RFT 26-083 Interior Renovations & Air Conditioner Upgrades at Frontenac PS

The following, issued by the Halton District School Board (HDSB) June 18, 2026, shall be incorporated in the specifications and shall form part of the proposal document for the above.

TENDER ADDENDUM NO. 1
2026.06.17

Interior Renovations and Air Conditioner Upgrades at Frontenac Public School
Halton District School Board RFT 26-083
5140 Pinedale Avenue, Burlington, Ontario

Drawing No.:
A1.1

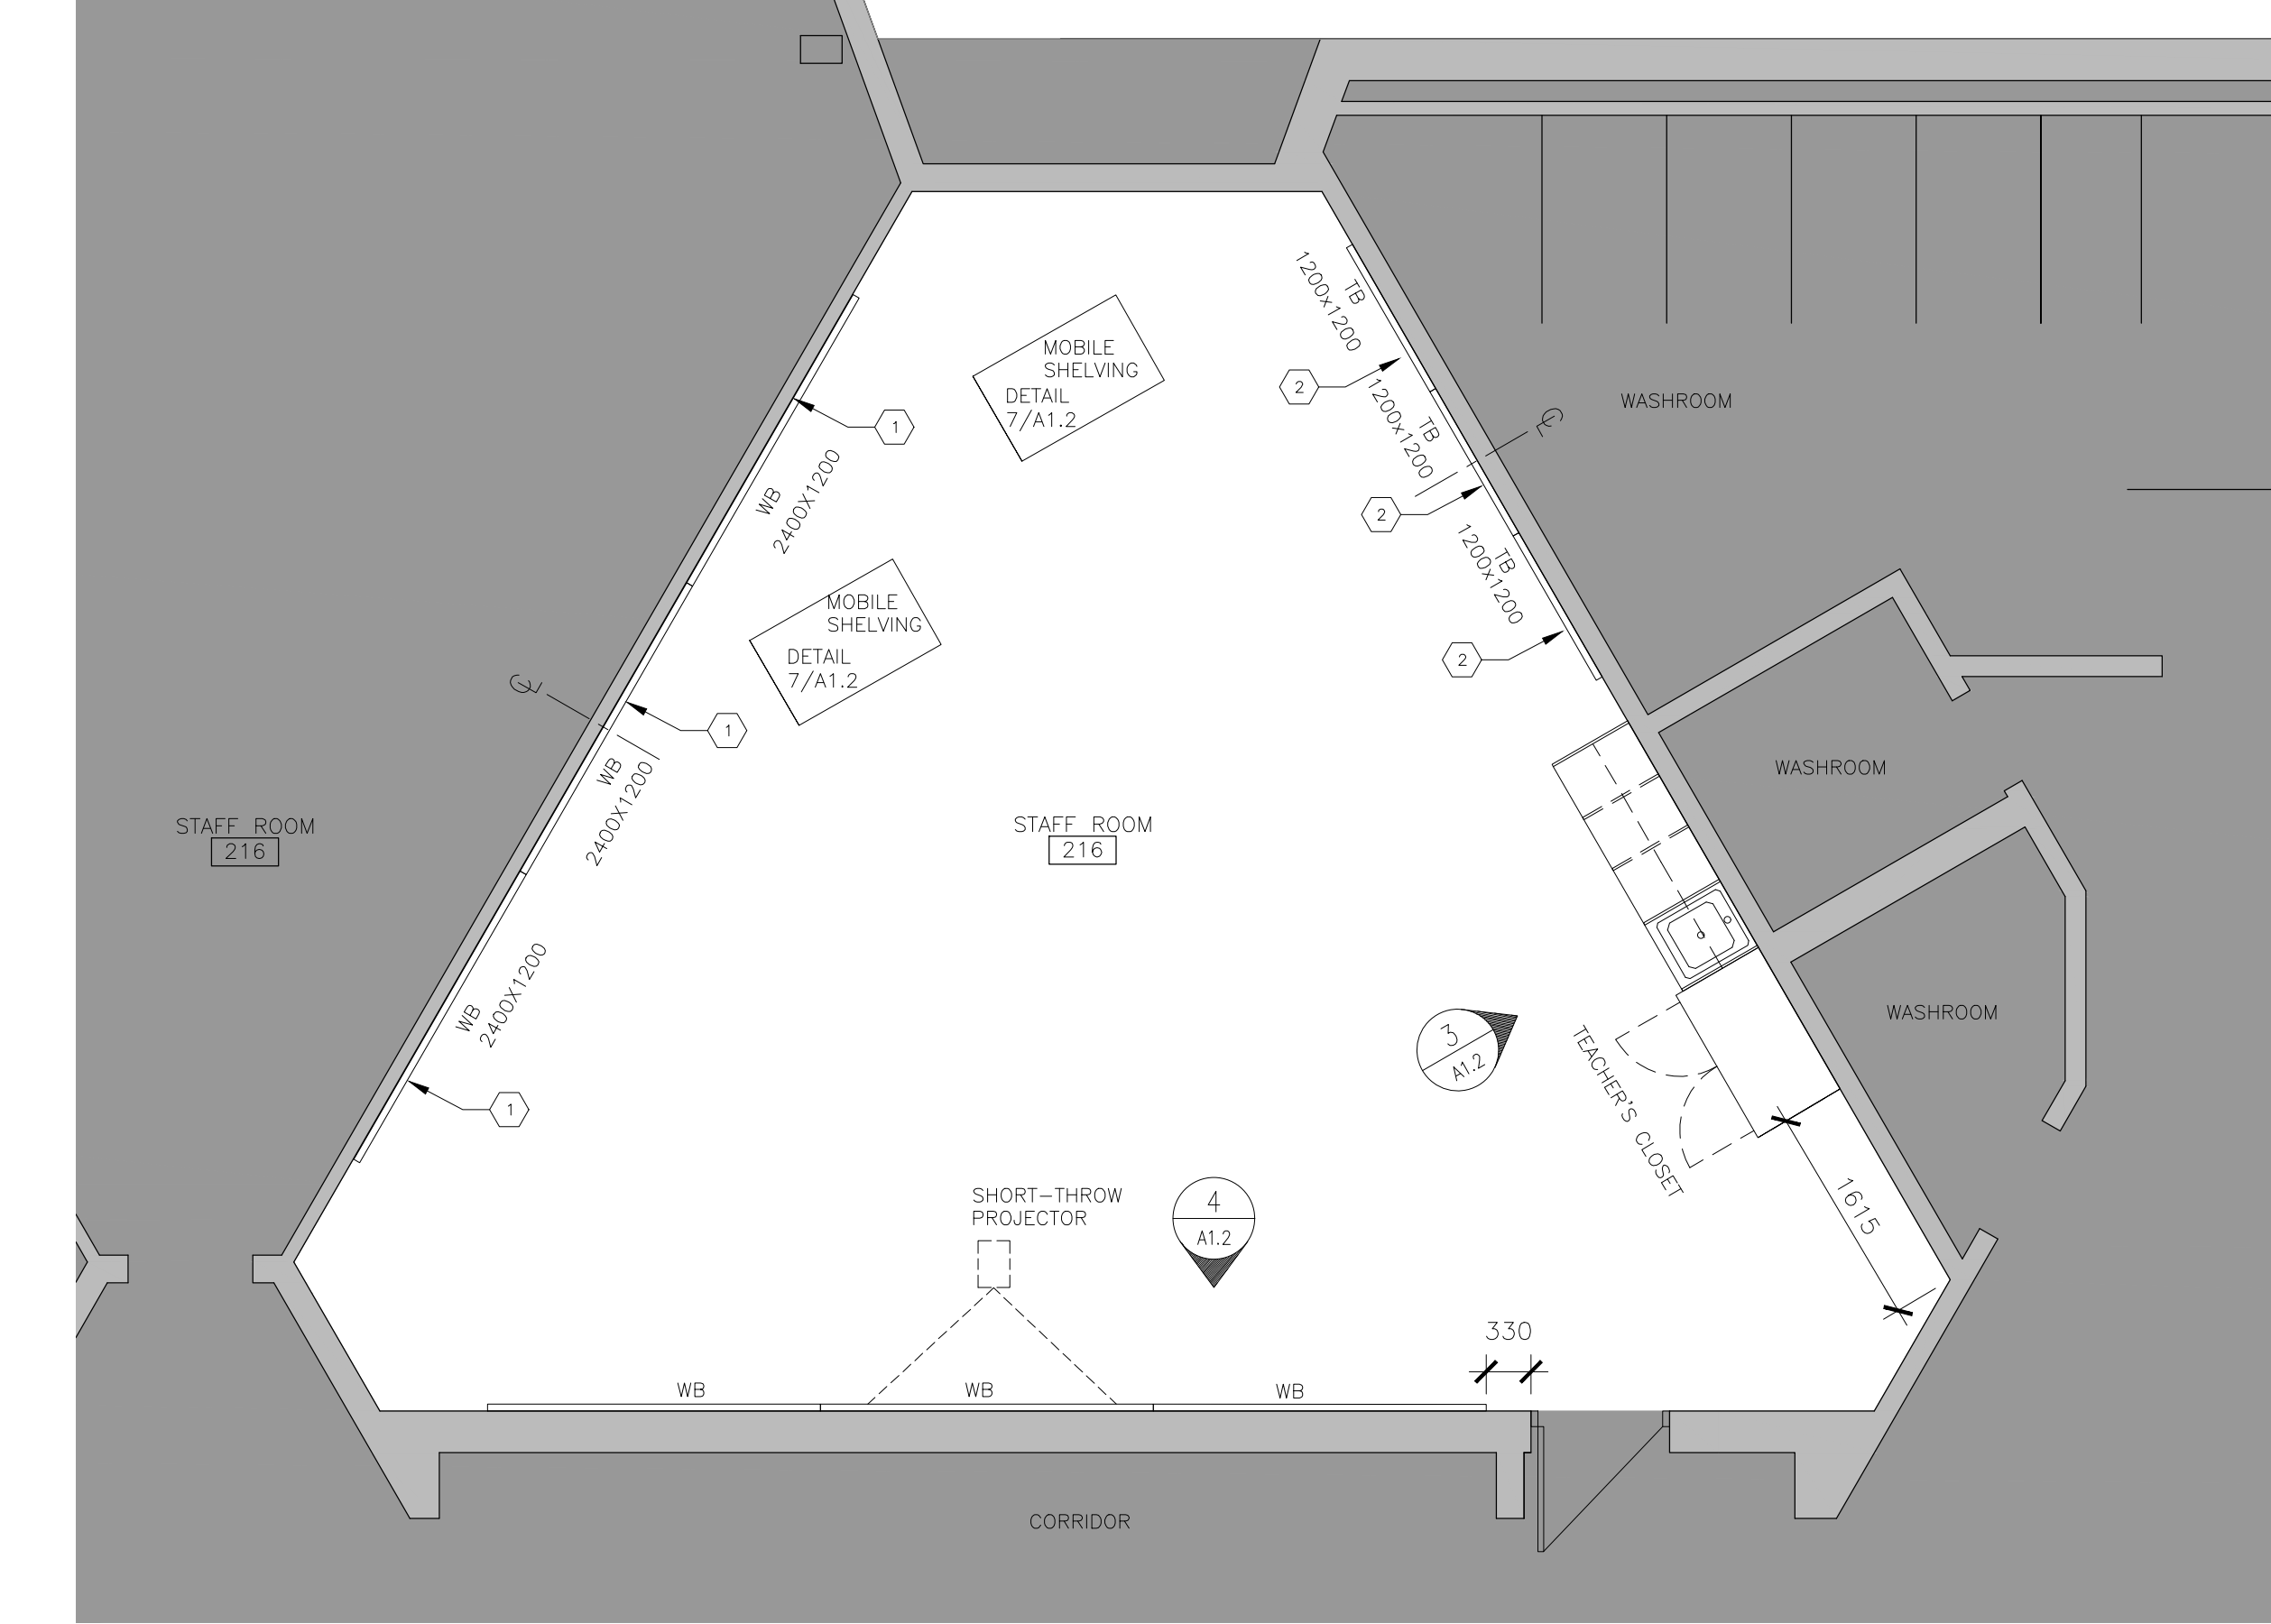
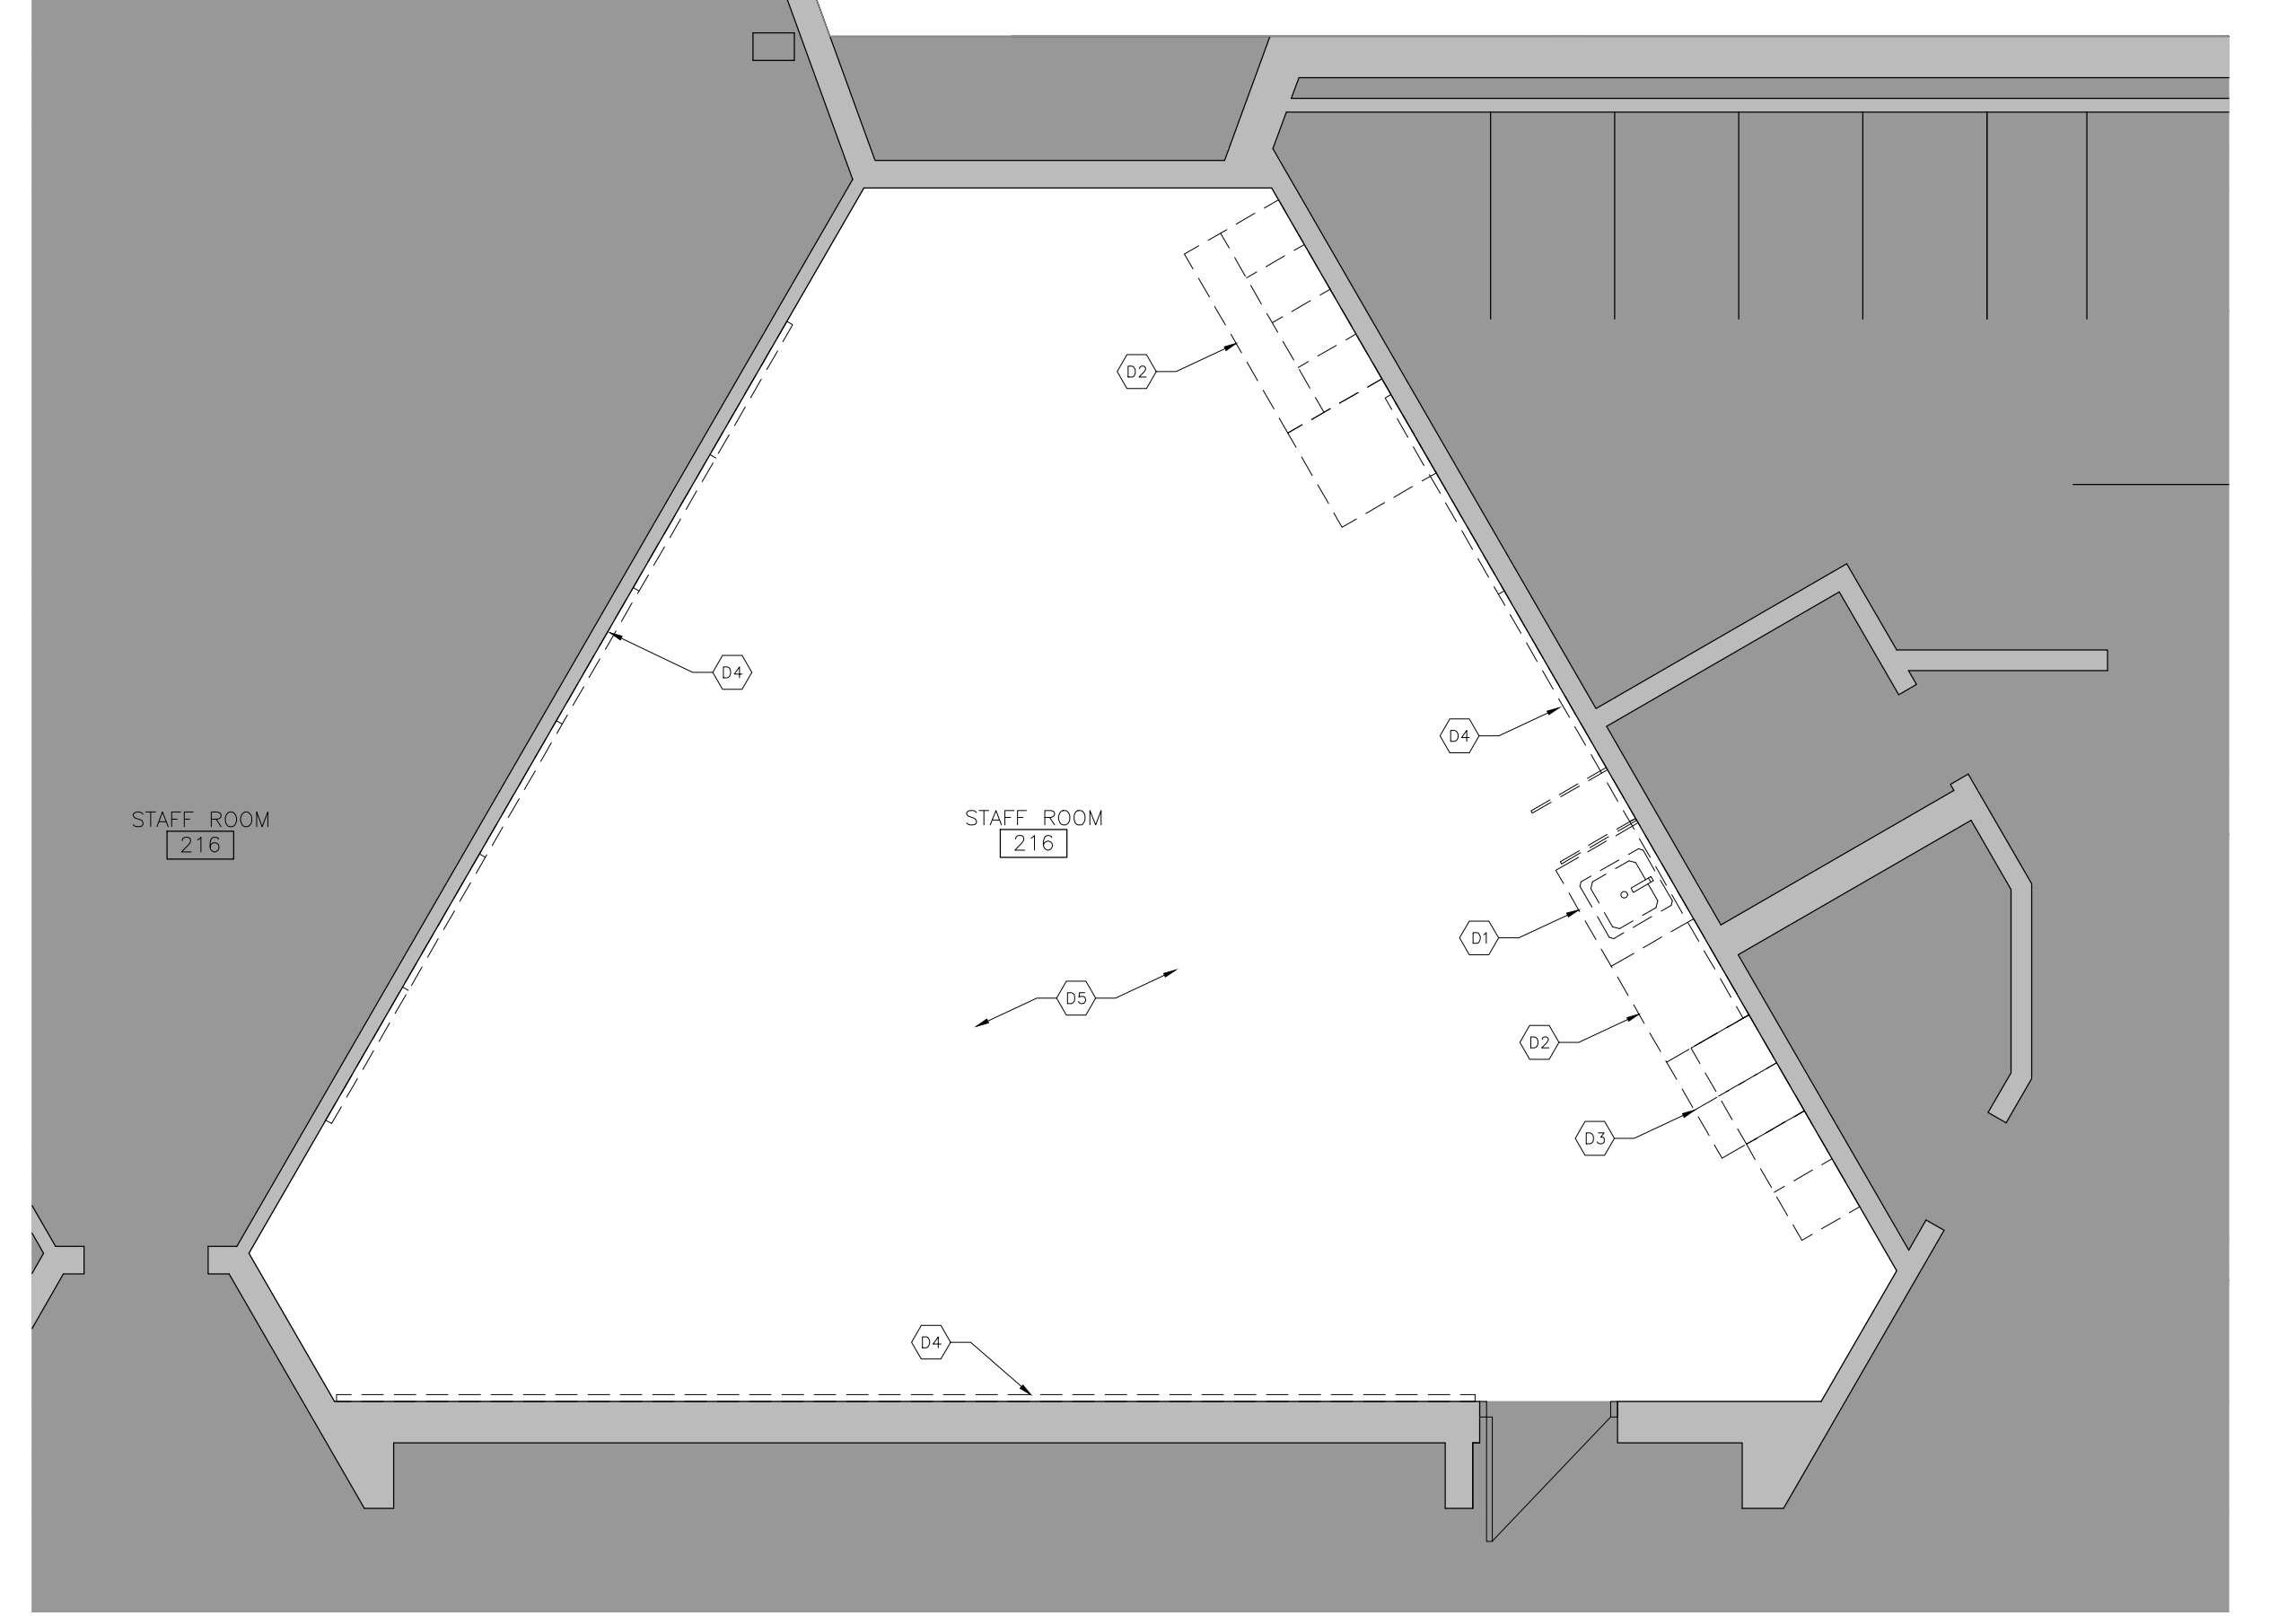
1.3: Drawing A1.1 Demolition & Proposed Floor Plans – Room 114:

1. ADD to Interior Elevations 1/A1.1 and 2/A1.1 reference bubbles to detail millwork sections. See attached revised drawing A1.1 with bubbled revisions.
2. ADD Millwork Section Detail 11/A1.1 and Interior Elevations 3/A1.1, 4/A1.1, 10/A1.1 and 12/A1.1. See attached revised drawing A1.1 with bubbled revisions.
